<i>Issue Date</i>	<i>Org. Code</i>	NATIONAL WEATHER SERVICE	<i>Program</i>	<i>Part</i>	<i>Section</i>
	W/OSO321	Engineering Handbook	EHB-11	02	3.6

MODIFICATION INDEX - AUTOMATED SURFACE OBSERVING SYSTEM

ASOS MODIFICATION NOTE 1 (for Electronics Technicians)
Engineering Division
W/OSO321:BGM

PURPOSE : To add maintenance capability and operational
enhancements for the ASOS.

FIGURE 1. ACU MEMORY BOARD EPROM LOCATIONS

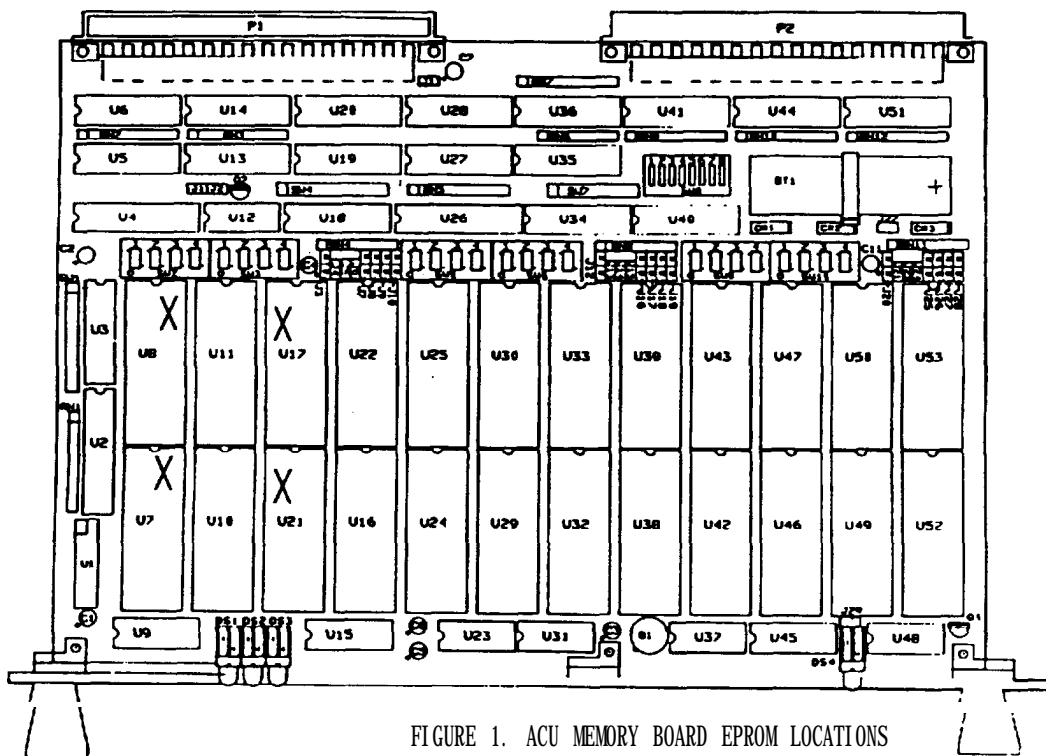
All ASOS application software is contained on four erasable programmable read only memory (EPROM) integrated circuits (IC) on ACU memory board 1A2A3. Figure 1 illustrates the ACU memory board and identifies the four EPROMs (U8, U17, U7, and U21). The EPROMs are 32-pin dual in-line package (DIP) CMOS devices, each providing 512K x 8 bits of storage. Upgrading ASOS software requires only replacing the four EPROMs on the ACU memory board with higher revision level ICs.

4. Using IC insertion tool, remove new EPROM integrated circuits from protective packaging and insert into ACU memory board sockets in accordance with the following chart. Ensure that EPROMs are installed with pin 1 (as identified by notch in top of IC) oriented toward board connector P1 as shown on Figure 1.

Figure 5.2.1, Temperature/Dewpoint Sensor Installation Diagram

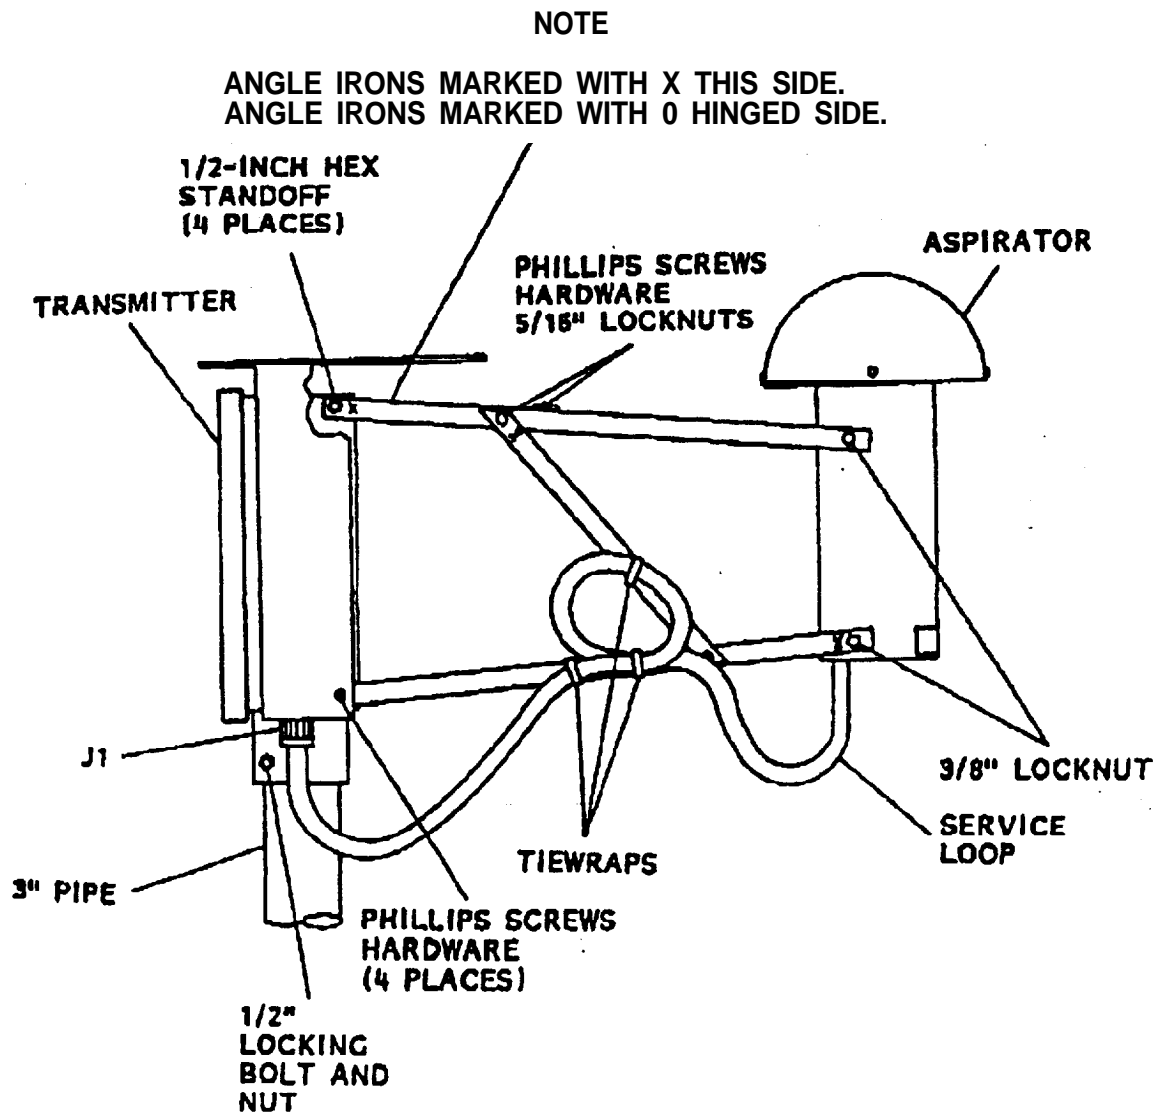
12. Using cable tie wraps, secure aspirator cable to support arm assembly as shown on figure 5.2.1. Be sure to leave service loop to allow removal of dewpoint sensor fan without cutting tywraps.

Figure 1 Visibility Sensor Electronics Enclosure

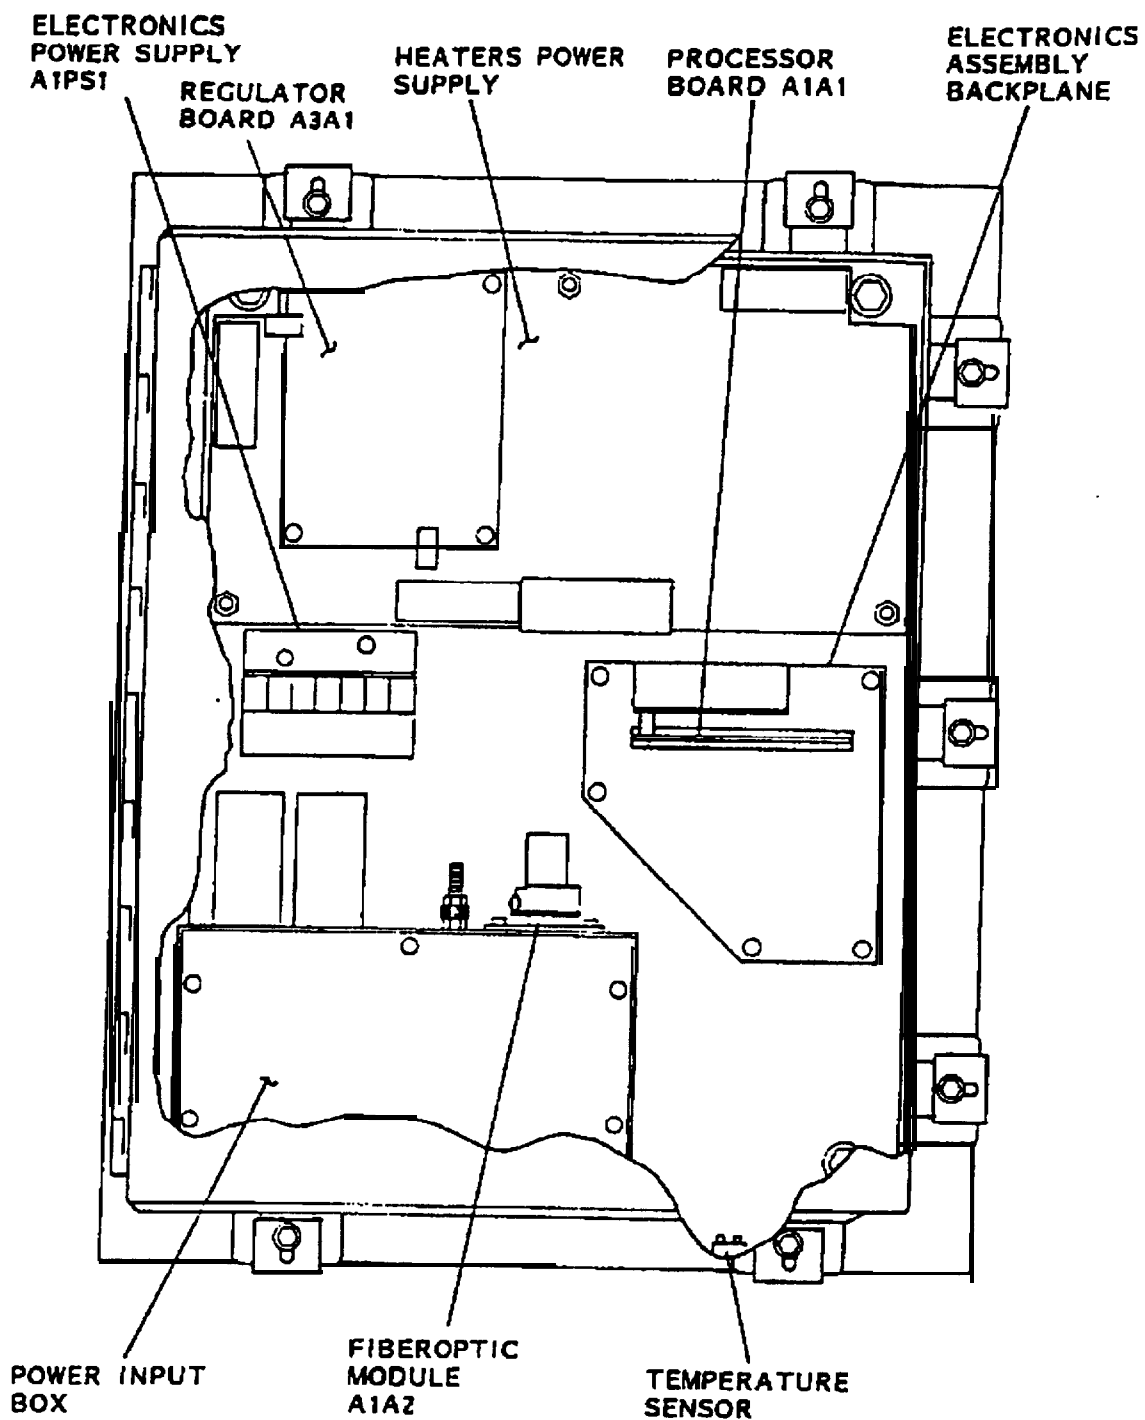
- 3.1 At the DCP, locate the circuit breaker for the visibility sensor and switch to the OFF position.
- 3.2 At the visibility sensor, remove hinge pin and lower sensor.
- 3.3 Open the electronics enclosure. Locate U2 on the processor board and remove the microcircuit using standard ESD precautions. See figure 2.
- 3.4 Install the new microcircuit supplied into U2 socket, assuring that pin 1 of the microcircuit matches pin 1 of the socket.
- 3.5 Disconnect the DB-9 cable connector from the fiber optic modem on top of the Faraday box.
- 3.6 Connect the PC to the DB-9 cable connector in the electronics enclosure. Set the PC to "2400, N, 8, 1" with CAPS LOCK to establish the correct communications protocol with the sensor.

FIGURE 4

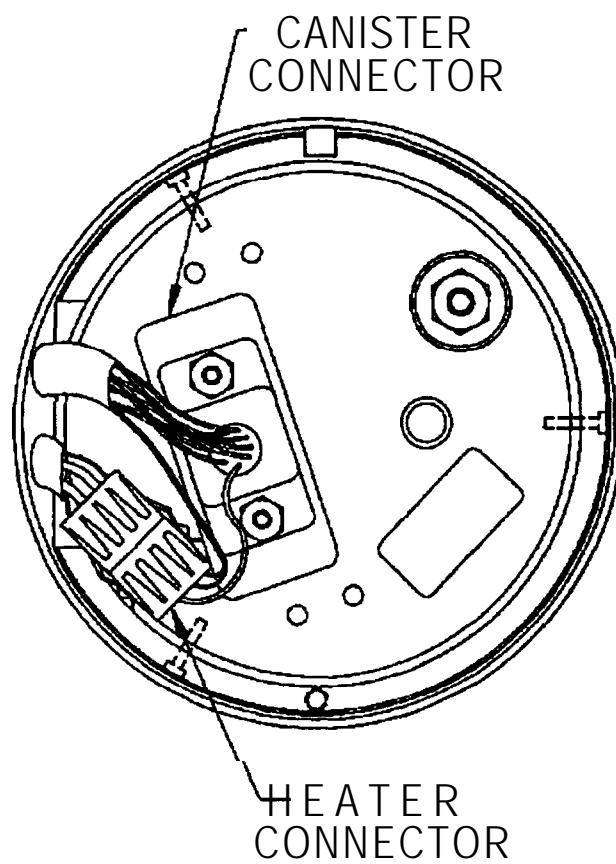
- 5.2 Using small flat-tipped screwdriver, slide locking mechanism (plate at front of connector) downward to unlock DB-9 connector. **DO NOT** disconnect the DB-9 connector at this time. See attached drawing of canister end view for connector location, Figure 4.

- 5.3 Repeat steps 5.1 and 5.2 for the receiver assembly.
- 5.4 At the PC, type "V3". The sensor will enter the "Heater Calibration" mode. Follow the instructions displayed on the PC screen. The "Heater Calibration" mode can be aborted at any time by striking the <ESC> key. See attached drawing of canister end view for connector location, Figure 4.

FIGURE 1

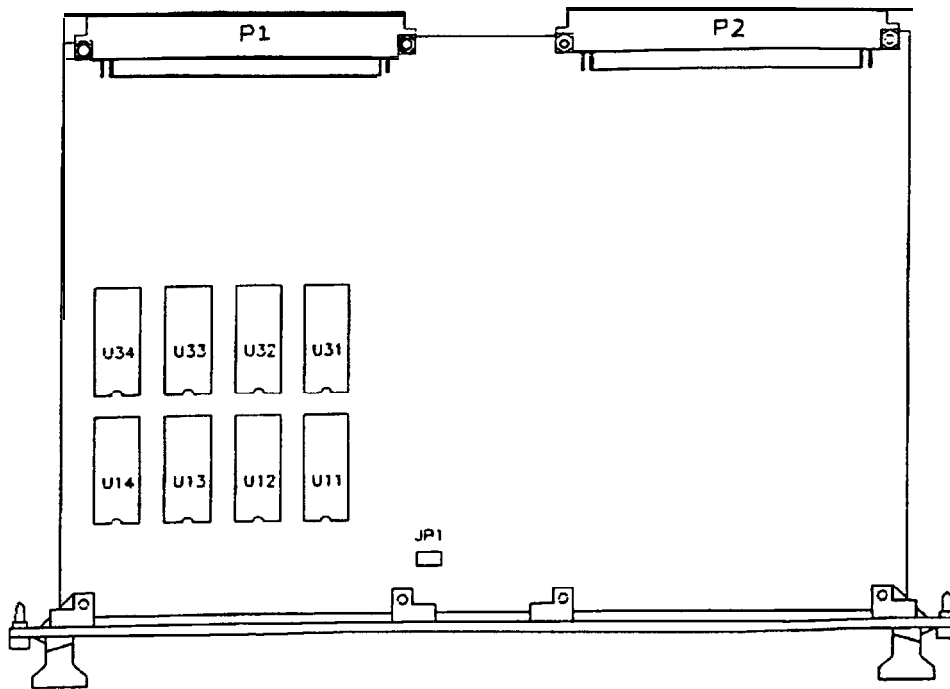
The procedure to upgrade the ACU voice firmware by removing and replacing the eight EPROMs on the Voice Processor board is followed. See Figure 1.

3. Using IC insertion tool, remove new EPROM integrated circuits from protective packaging and insert into Voice Processor board IC sockets in accordance with the following chart. Ensure that EPROMs are installed with pin 1 (as identified by notch in top of IC) oriented toward top of Voice Processor board as shown on Figure 1.

FIGURE 1.

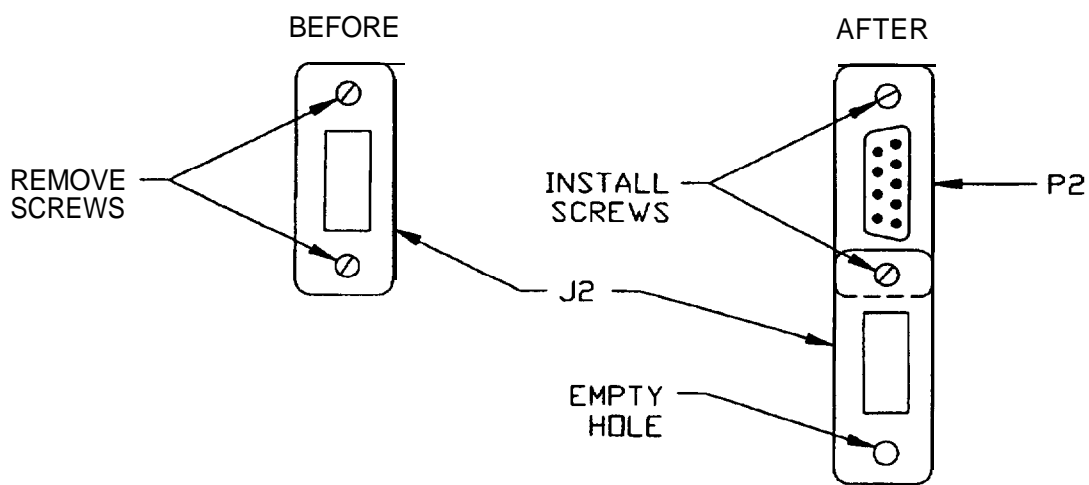
1. Follow normal procedures for maintenance and powering down the hygrothermometer.
2. Turn power to the hygrothermometer off at the DCP.
3. Locate the autobalance module A5. Disconnect the autobalance 9-pin, D-type connector J2. Restrain the plug by attaching one side to the mating connector. Replace the remaining screw and washer into the other side of the mating connector. See Figure 1 for details.
4. Turn power on to the hygrothermometer.
5. Clean the mirror and calibrate the optical loop using ASOS Site Technical Manual Procedures (reference chapter 5).
6. Follow normal procedures for returning the ASOS to normal operation.
7. Make appropriate entries in the SYSLOG using the Maintenance Action keys, Field Modification keys, and comment fields. Follow these steps:

FIGURE 1

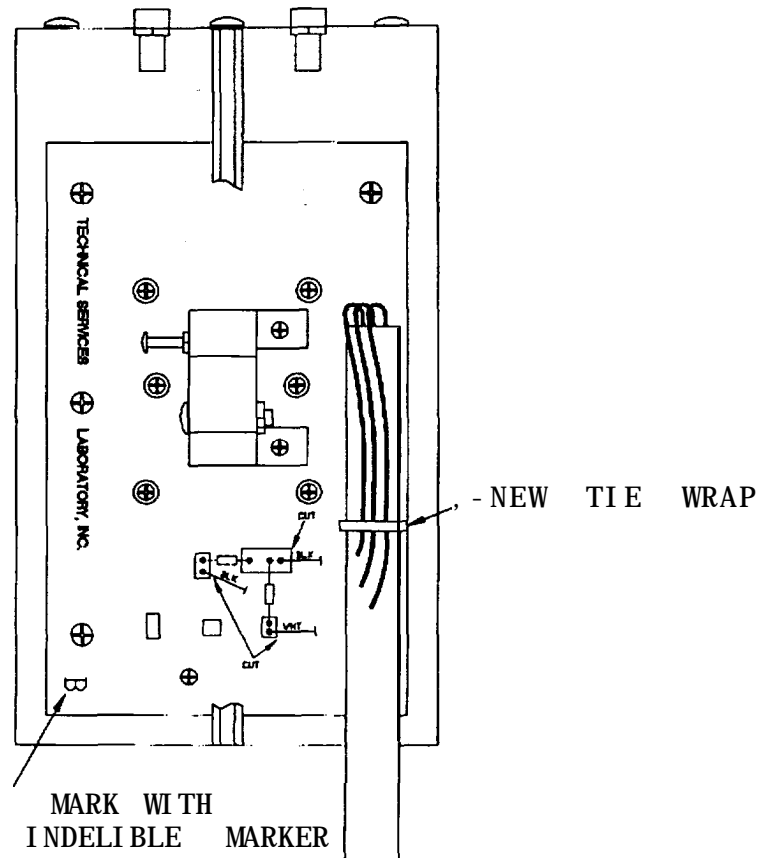
9. Use an indelible marker to mark the card with a "B" as shown in Figure 1.
 10. Reinstall the dew point sensor into the aspirator.
 11. Turn the fan fail potentiometer fully counterclockwise.

FIGURE 1. ACU MEMDRY BOARD EPROM LOCATIONS

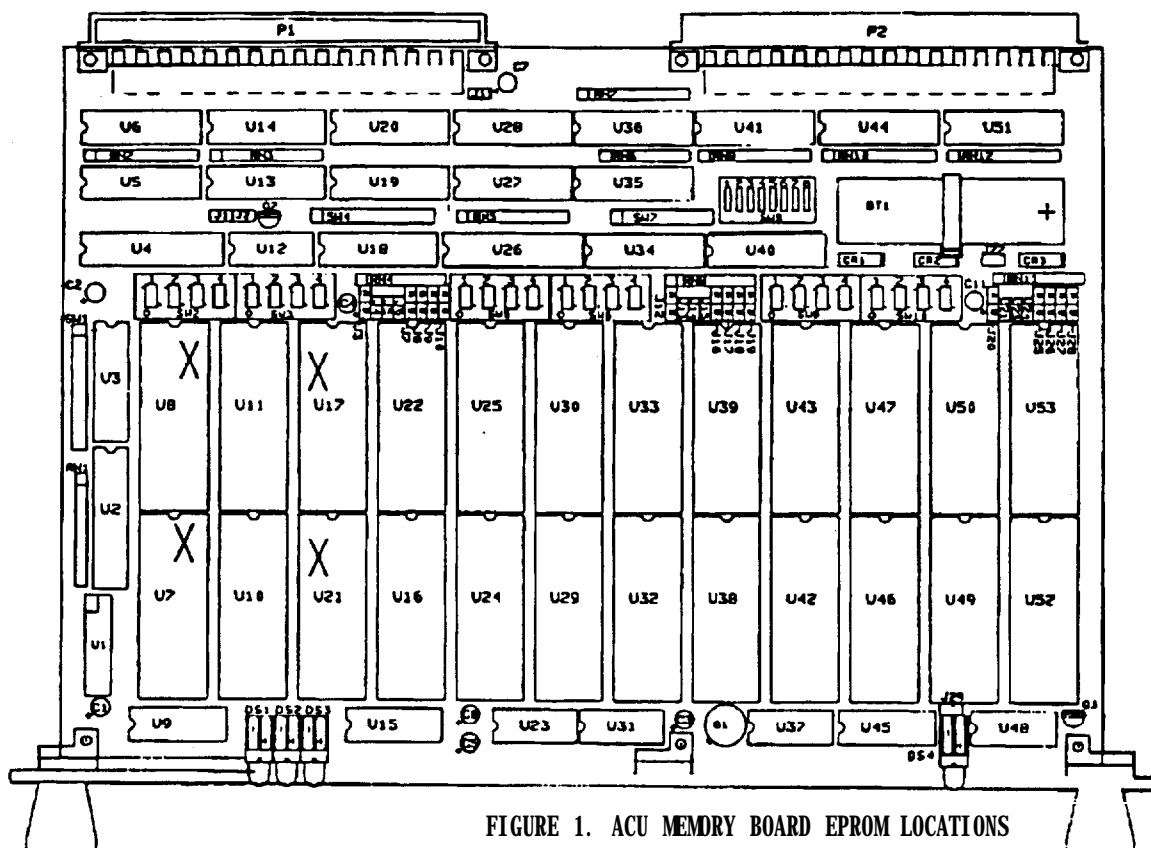
All ASOS application software is contained on the four erasable programmable read only memory (EPROM) integrated circuits (IC) on ACU memory board 1A2A3. Figure 1 illustrates the ACU memory board and identifies the four EPROMs (U8, U17, U7, and U21). The EPROMs are 32-pin dual in-line package (DIP) CMOS devices, each providing 512K x 8 bits of storage. Upgrading ASOS software requires only replacing the four EPROMs on the ACU memory board with higher revision level ICs.

If the ACU EPROMs in the system are 1.70 or higher, the ACU is no longer cold started by removing battery jumper J22 (Figure 1) to clear all RAM on the board. The next step requires receiving a download of site-specific data from the AOMC. The DCPs are cold started by performing a hard reset of each DCP from the processor status page on the OID. After completion of the upgrade procedure, the EPROMs removed from the ACU memory board should be packaged in appropriate electrostatic discharge (ESD) protective material for return.

Figure 2

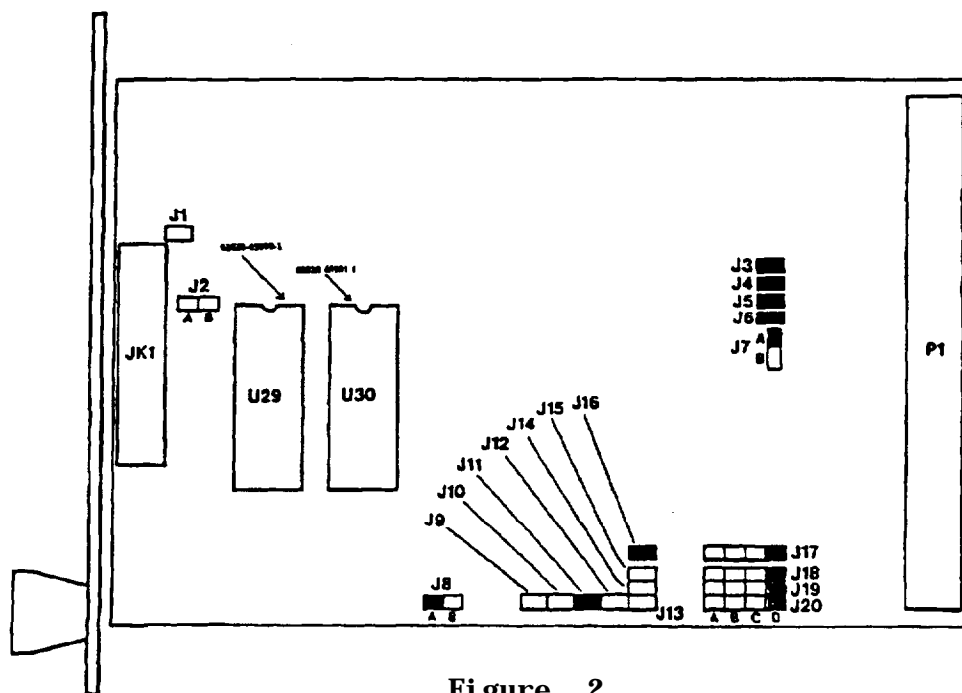
All pSOS ASOS application software is contained on the four EPROM ICs on the ACU CPU board 1A2A1 and 1A2A2. Figure 2 illustrates the ACU CPU board and identifies the two EPROMs (U29 and U30). The EPROMs are 28-pin DIP CMOS devices, each providing 256K x 8 bits of storage. Upgrading pSOS ASOS software requires only replacing the two EPROMs on the ACU CPU board with higher revision level ICs.

FIGURE-1 LOCATION OF FRUs IN LEDWI ELECTRONICS BOX

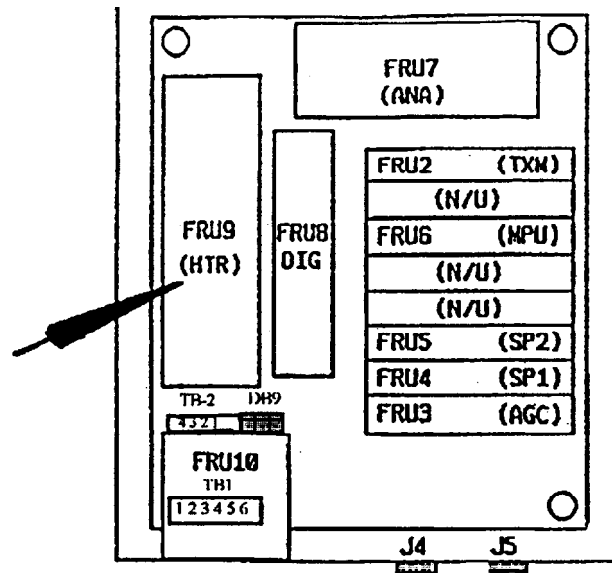
1. At the DCP, turn the LEDWI circuit breakers to "OFF".
2. At the LEDWI, open the electronics enclosure door.
3. Remove the MPU card located in the card cage, 3rd slot from the top. Refer to Figure 1.

1. Locate FRU9 using Figure 1.
2. Connect a DVM to FRU9 using Figure 2 as a guide. The (+) lead of the DVM connects to the (+ OUT) bifurcated terminal and the (-) lead of the DVM connects to the (-OUT) bifurcated terminal.
3. At the DCP, turn the LEDWI circuit breakers to "ON."
4. Adjust heater power supply voltage. Using Figure 2, locate R11(V. Adj) on FRU9. Adjust R11 clockwise until the DVM reads 28 ± 0.02 VDC. Read the DVM and record the voltage here: _____VDC.
5. Heater power full load check and adjustment. Block the transmit beam for several minutes to turn on the hood heaters. After 2-3 minutes, determine if heaters are ON by feeling for heat.

FIGURE- 3

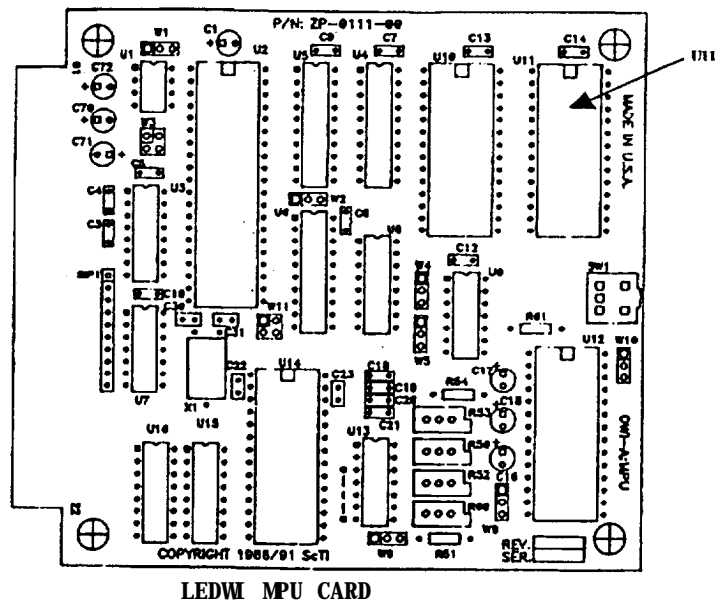
4. Referring to the attached drawing LEDWI MPU card, carefully remove the EPROM located in the U11 position. Refer to Figure 3.
